**WEST VIRGINIA ENVIRONMENTAL QUALITY BOARD
CHARLESTON, WEST VIRGINIA**

Appeal No. 20-13-EQB

APPELLANTS' MOTION FOR STAY

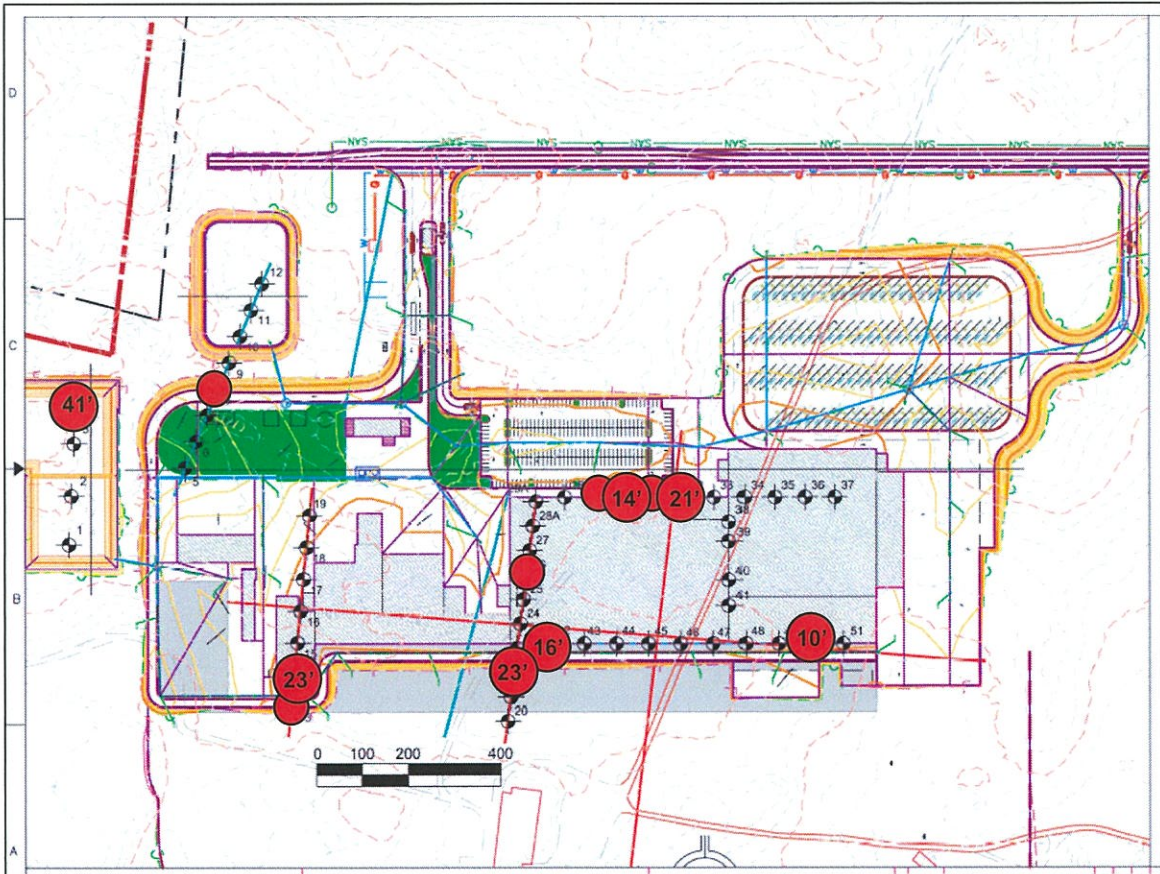
Further review of the Thrasher (2017) geotechnical investigation is a game changer in making clear the remarkable quantity of void space present in bedrock beneath the site. During this investigation 53¹ air track holes were drilled into the bedrock beneath the facility (Figure 3) and 12 of them, more than 20%, had voids at least one foot in height. Seven, more than 10%, had total void height of ten feet or more. Four, more than 7%, had total void height of 20 feet or more, and well 4—beneath the Reuse Pond and less than 200 feet laterally from Outfall A—*has a total void space equal to the height of a four-story building*.

Two related observations critical to understanding the subsurface at the site (Figure 3) are that every line of drillholes encountered bedrock voids, and for the most part, the areas of the map in which no voids are shown are areas without drill holes. For a first approximation of subsurface conditions at the site it doesn’t take much imagination to mentally project sets of lines with similar void densities across the site—there is no evidence to suggest that the random positions of the drilling lines encountered a higher density of voids than to be expected in other areas.

Inset from The SWPPP Figure 2A

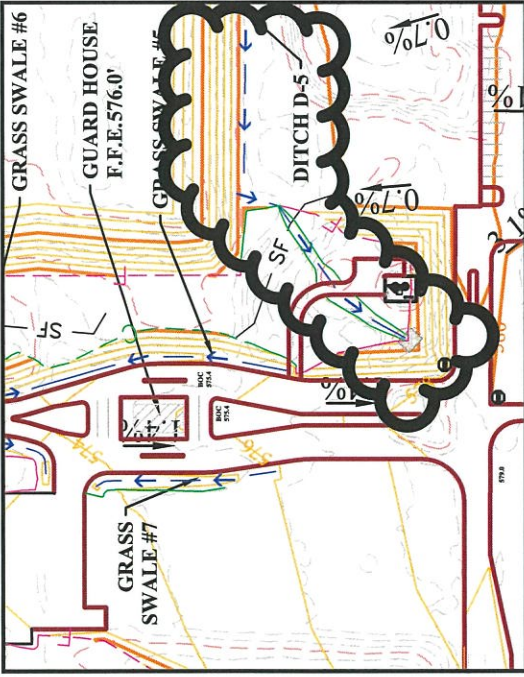
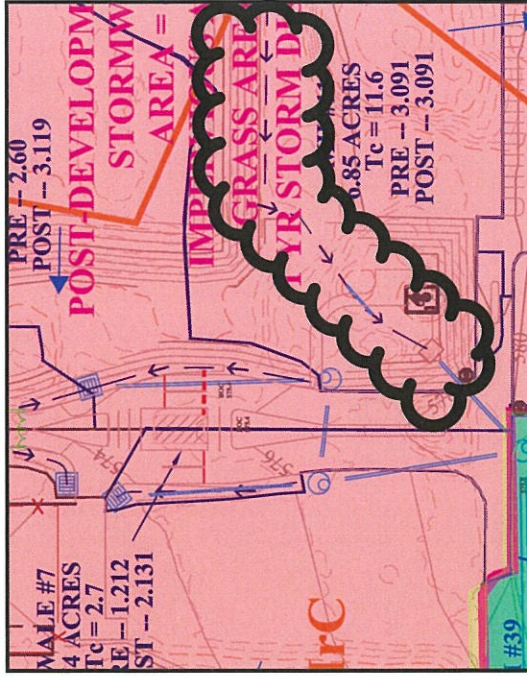
For example, in Figure 2A and Figure 3, at the southeast corner intersection where the main entrance drive meets the internal site access road, a stormwater drainage swale and inlet with a piped connection that discharges runoff to the site's stormwater management pond is shown. However, in Figure 2B, a designated solid waste area is shown in this location directly over the inlet and the swale; see Exhibit 2A-1. Either the solid waste area needs to be moved to a location where it is not obstructing any stormwater systems, or the swale and inlet needs to be relocated. Regardless, all figures should be updated to consistently reflect the current and intended design.

Inset from The SWPPP Figure 2B

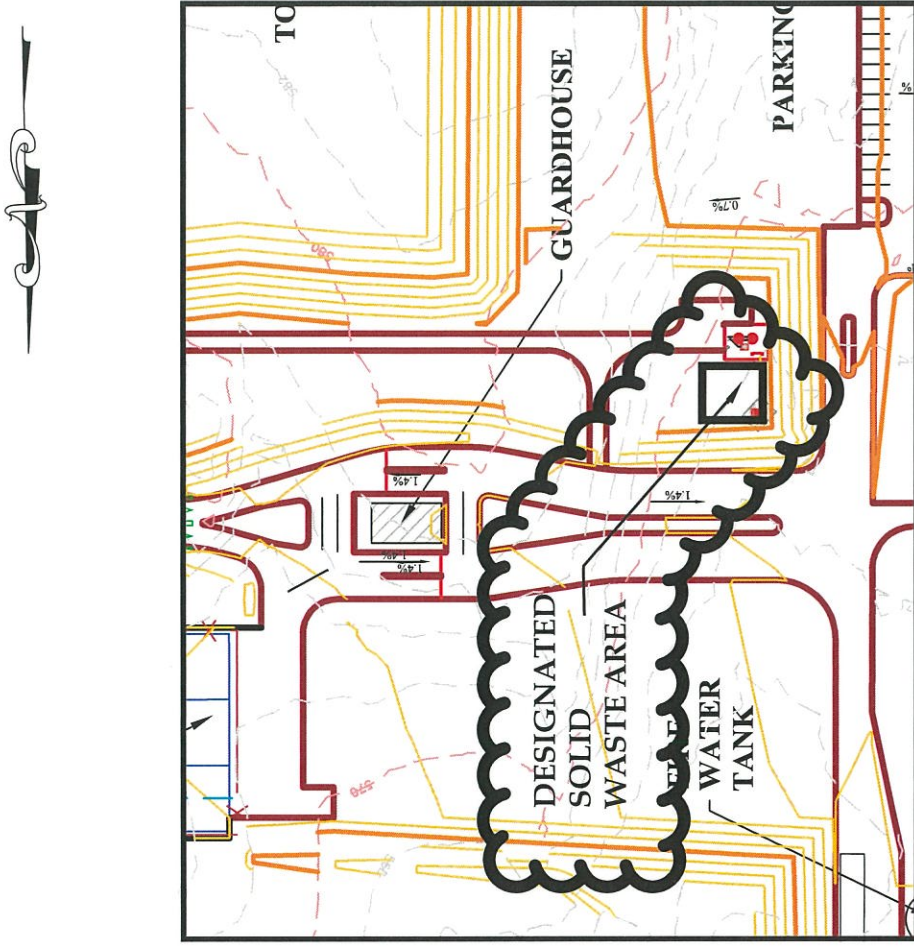
Another example of conflicting information is the diesel above ground storage tank (AST) shown northwest of the utility building and inbound of the site access road on Figure 2B. According to Figure 3, this tank is also located on top of drainage inlet #33; see Exhibit 2A-2. Further information on this AST could not be located in The SWPPP according to its "Diesel-1 1,200 gallon" identification. Either the AST needs to be moved to a location

Inset from The SWPPP Figure 2A

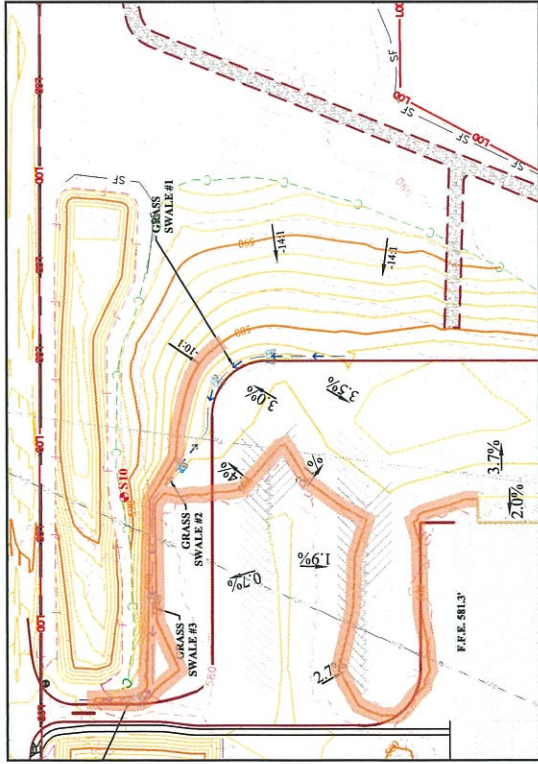
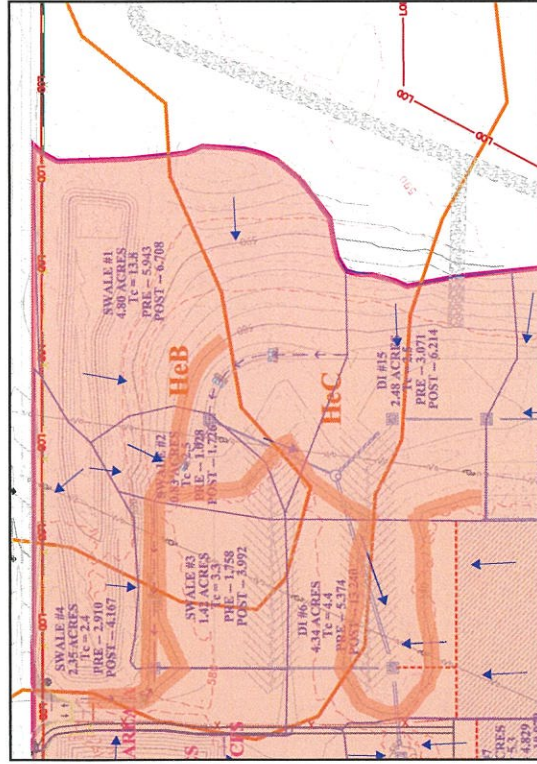
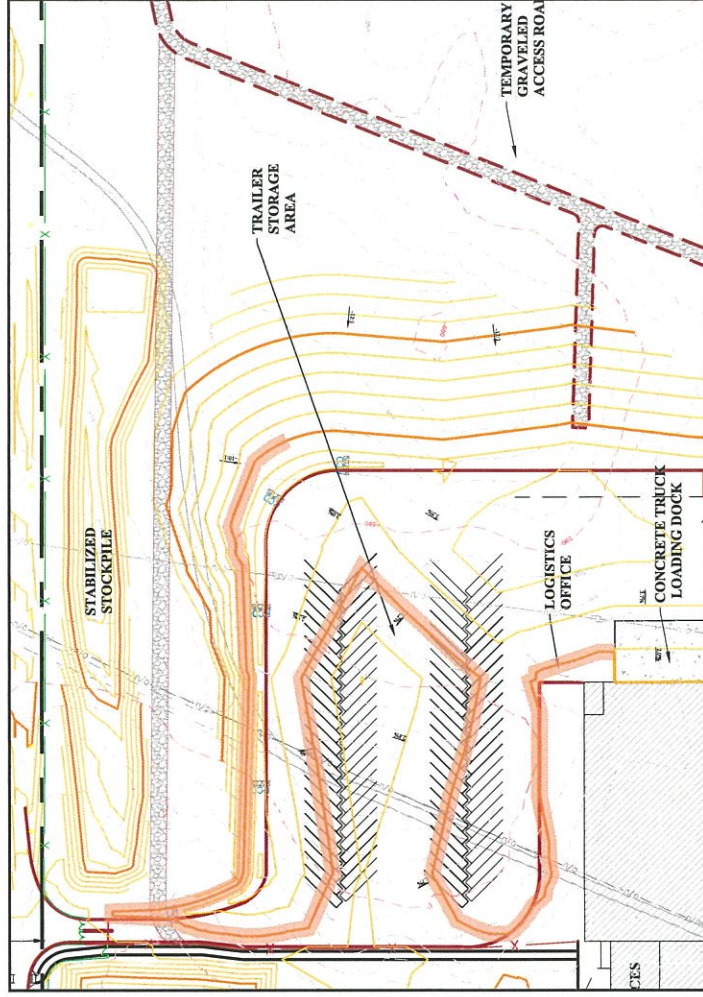
When reviewing Figure 2A and Figure 3 compared to Figure 2B, a clear difference in the grading design and parking lot layout at the southwest area of the site is evident between figures raising questions on the drainage intent of this area; see Exhibit 2-B. This discrepancy should have been inquired about and The SWPPP should not have been approved given the lack of clarity on site runoff patterns. The correct site layout should be shown on all figures as well as a consistent grading design.

EXHIBIT 2B

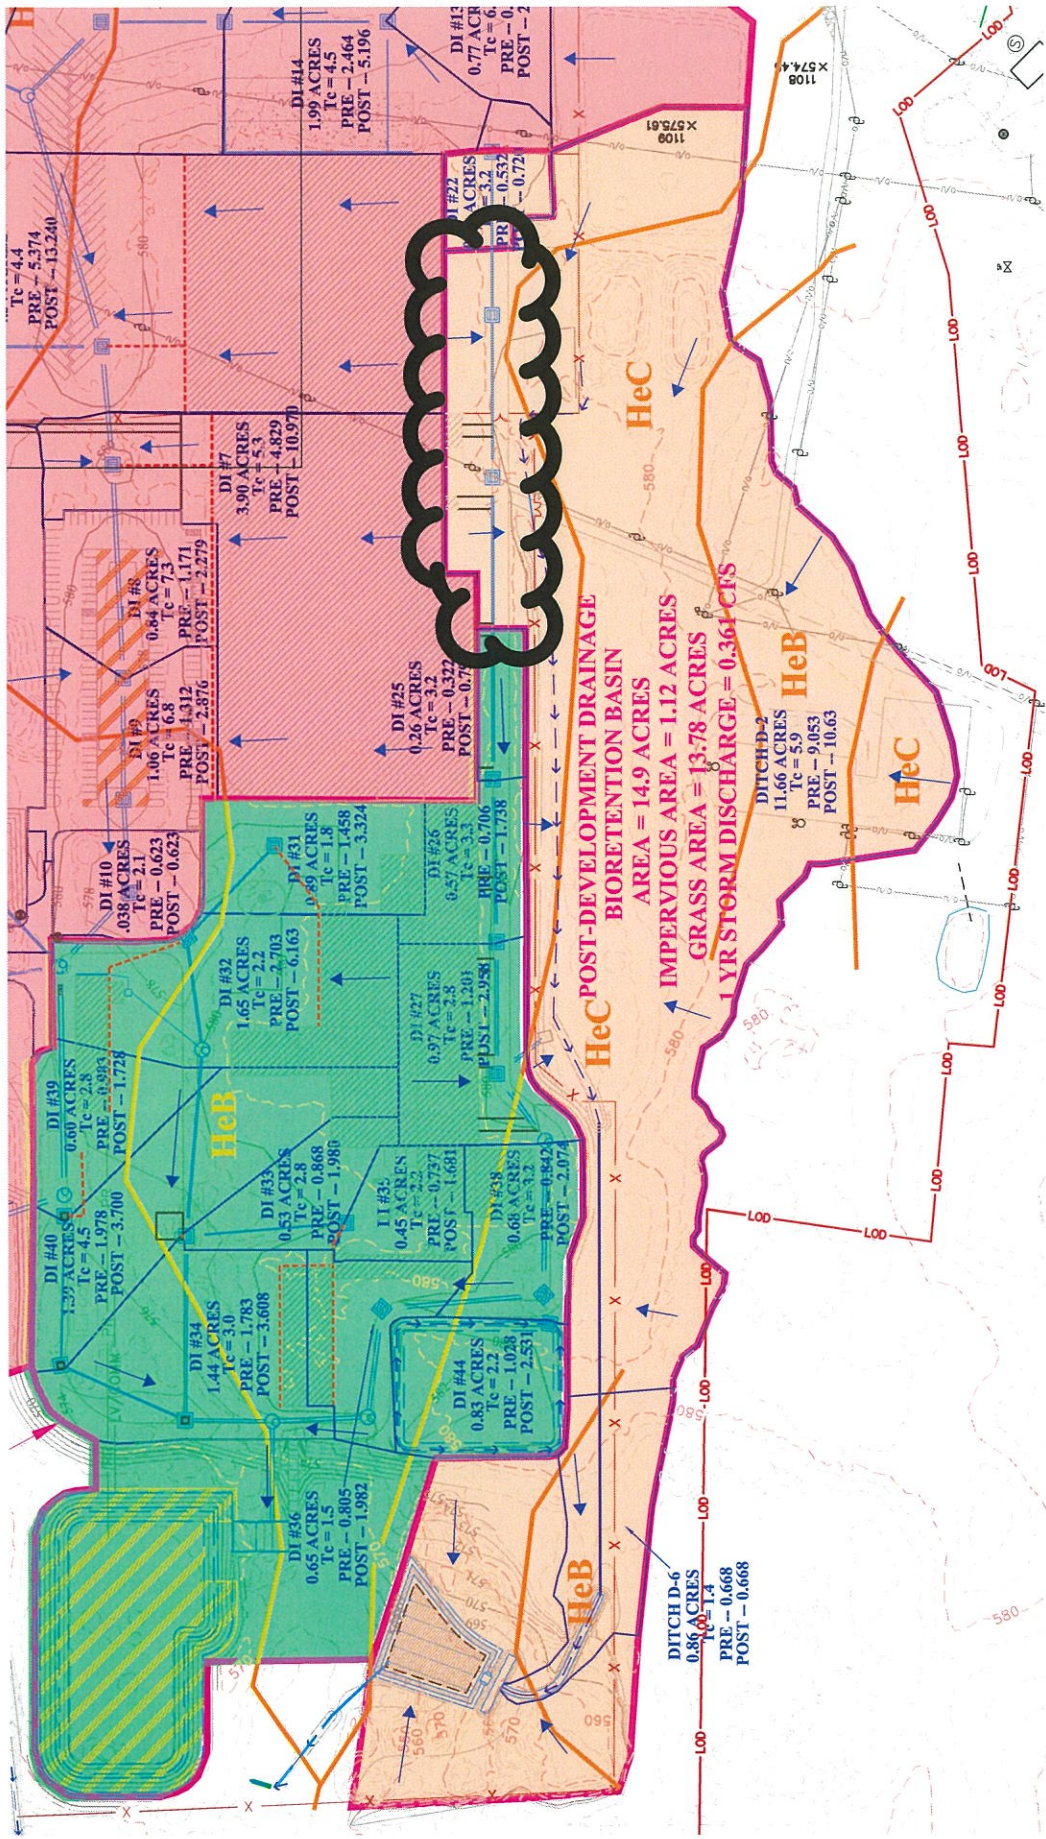
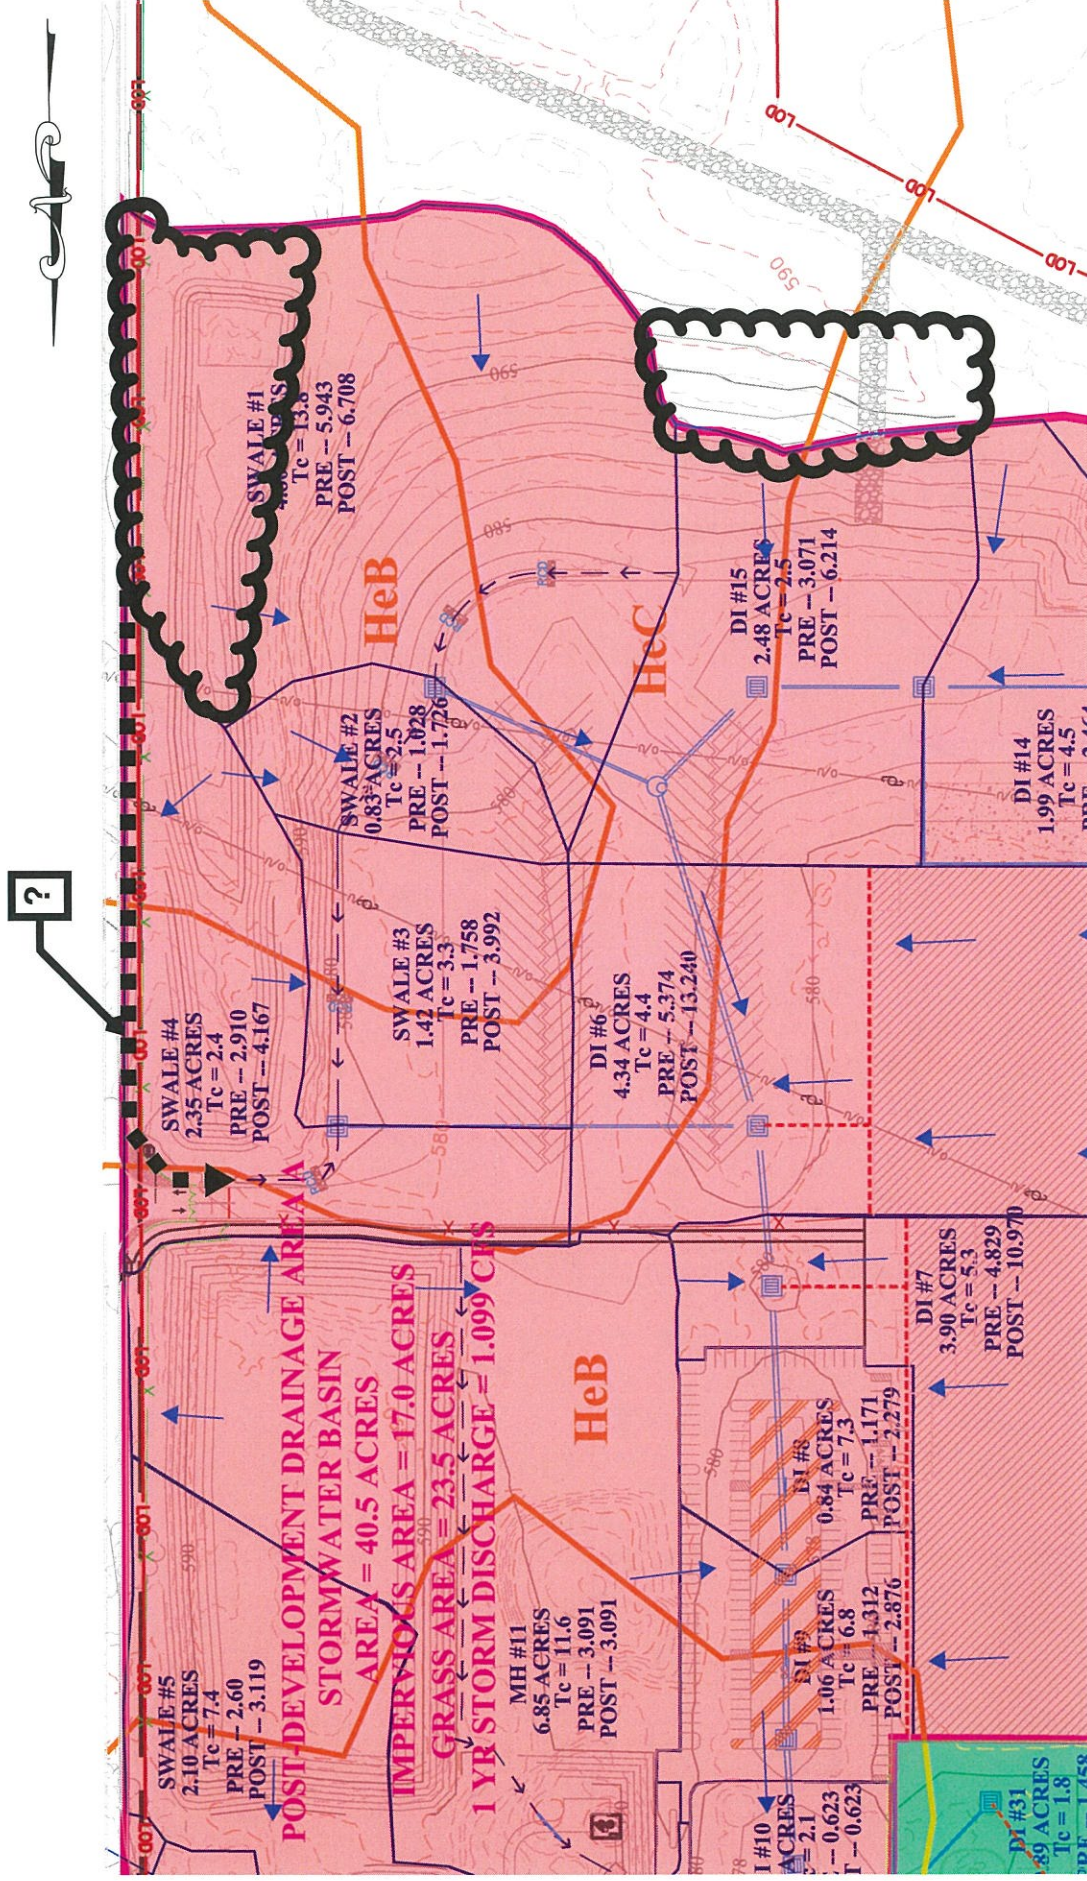
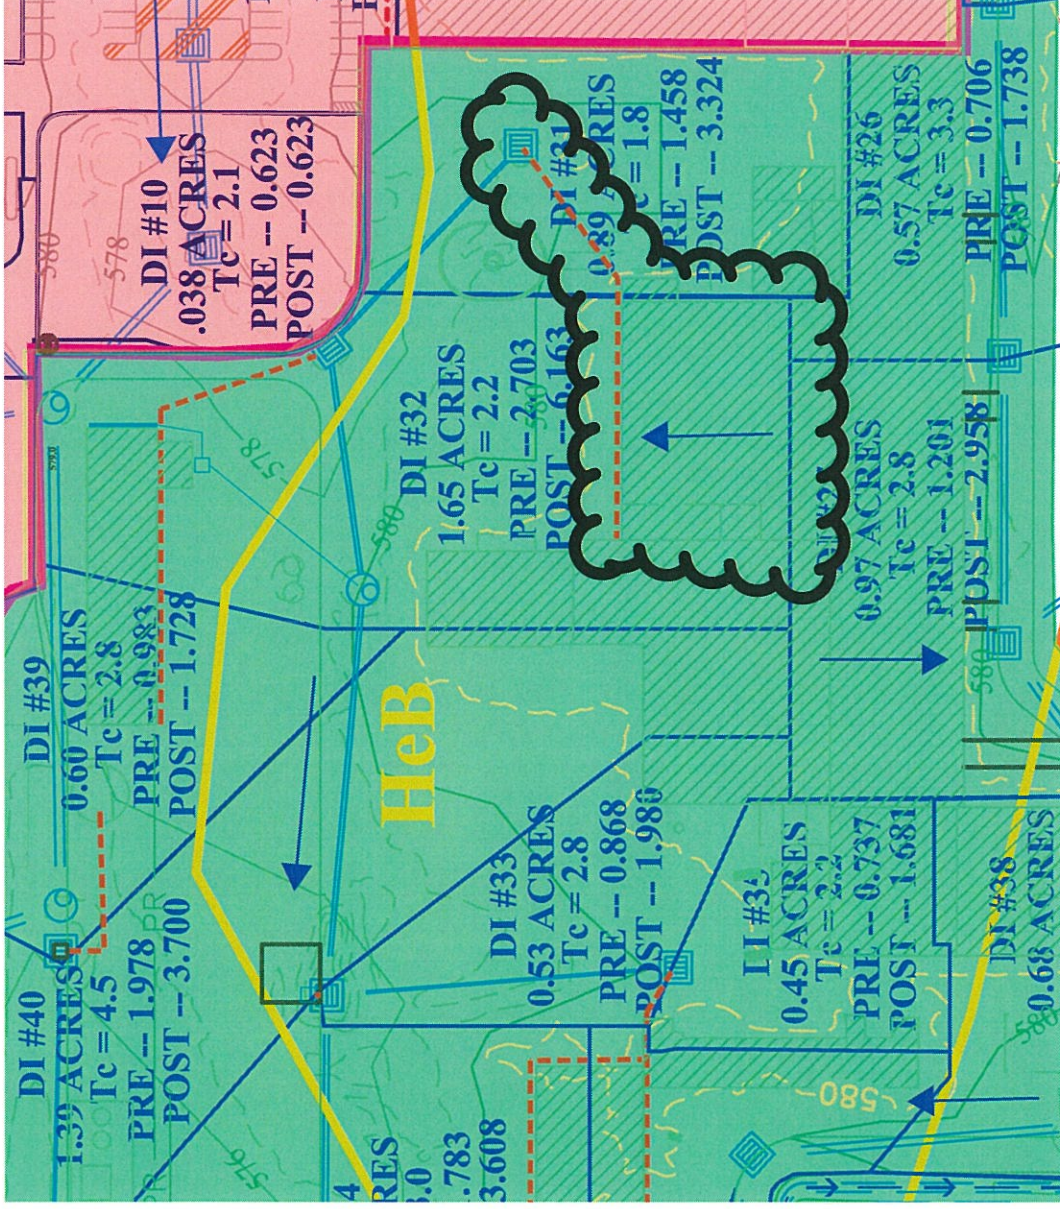
- o Post Development Drainage Area A Stormwater Basin - The delineated drainage area associated with the Stormwater Management Pond is shown on Figure 3 of The SWPPP and Figure 4 of The GPP. The drainage area characteristics are reported as having an overall size of 40.5 acres that includes 17.0 acres of impervious cover and 23.5 acres of grassed area. However, upon review of this drainage area, the southern and eastern limits are not properly delineated.

The southern border, which includes drainage inlet (DI) number 15, is not shown correctly. The contours in this area clearly show a minimum of 0.5 acres of additional contributing runoff that was not included to subdrainage area DI#15; see Exhibit 3-B2.
